MAWC RESPONSES

1. Paragraph 22 of the Stipulation of Facts states “As part of the water main extension needed for the development, DCM is installing a 12” main in place of an existing 4” main in Old Town Cottleville. That replacement would improve fire protection in the area and provide water main access to several additional properties nearby.”

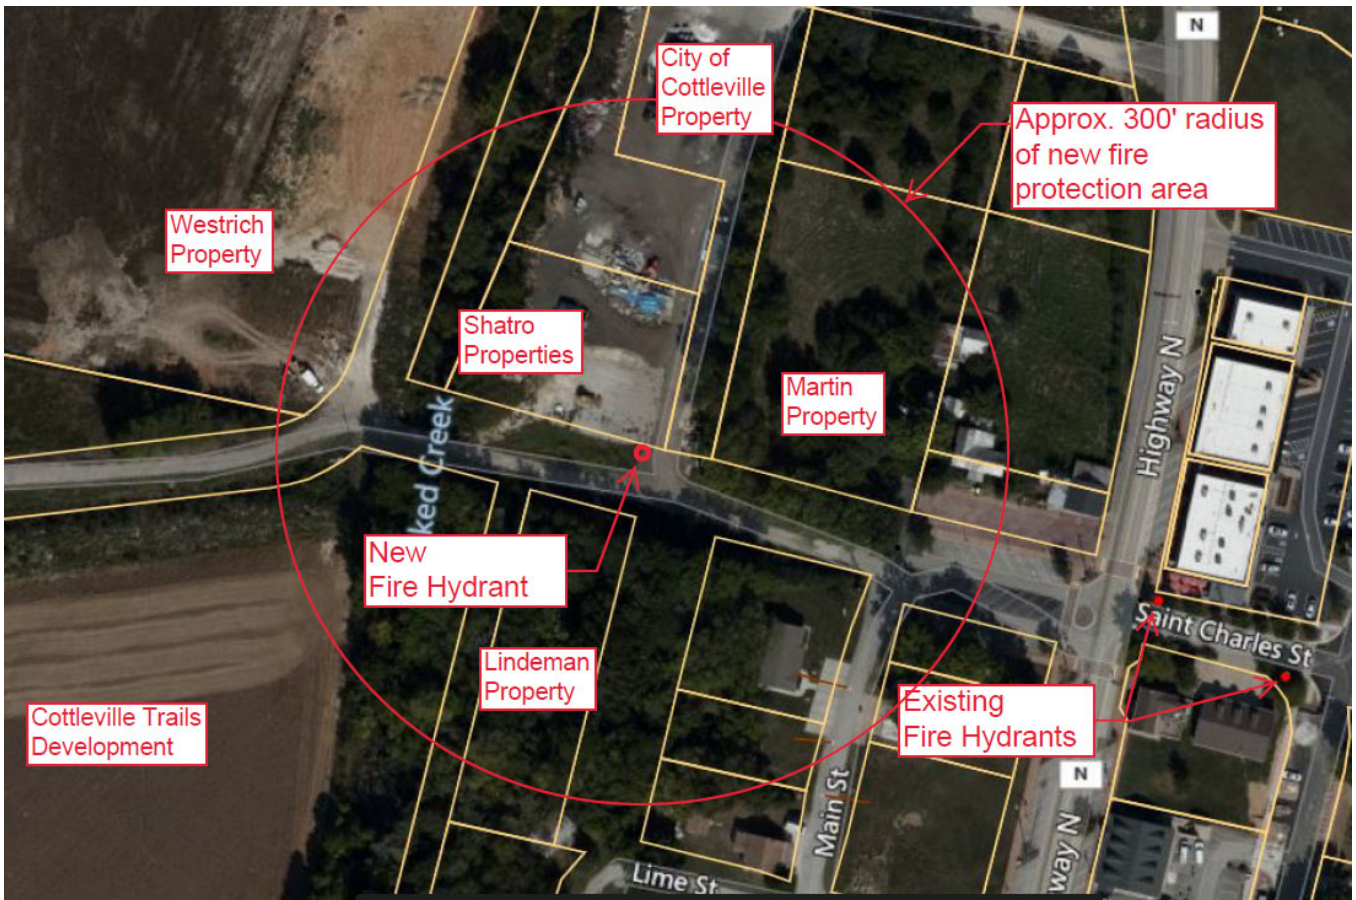
a. What area(s) will be provided fire protection through the expansion of the main?

b. Does this fire protection cover areas besides DCM’s development of Cottleville Trail Development?

a. Are these properties outside of the Cottleville Trail Development?

See map below showing new fire hydrant with 300’ radius (estimated coverage area).

Yes. It also covers all or portions of several properties just west of downtown Cottleville (see map above).

Yes, see the map above. The Lindeman, Westrich, Shatro, Martin, and City of Cottleville properties labeled above previously did not have frontage to an existing MAWC water main.
